Ref: MRBR-23H004

Field Safety Notice

RADspeed Pro
RADspeed safire
CEILING TUBE SUPPORT CH-200
CEILING TUBE SUPPORT CH-200M

Fig. 1 Rotation around Vertical Axis

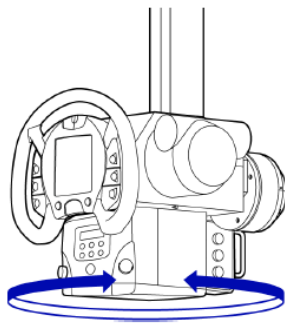
- Perform daily inspections according to the CH -200/CH -200 M operation manual. In particular, check if there is any abnormality such as the X-ray tube device being able to rotate around vertical axis (see Fig .1 below) without pressing any button on the control panel. if any abnormal points are observed, stop using the equipment and contact Shimadzu service representative.
- When rotating the X-ray tube assembly, do not hit the X-ray tube assembly against the stopper at the end.
If the X-ray tube assembly is hit hard against the stopper, the bolt may be impacted, causing it to loosen and break.
- Do not rotate the X-ray tube assembly above or near the patient.
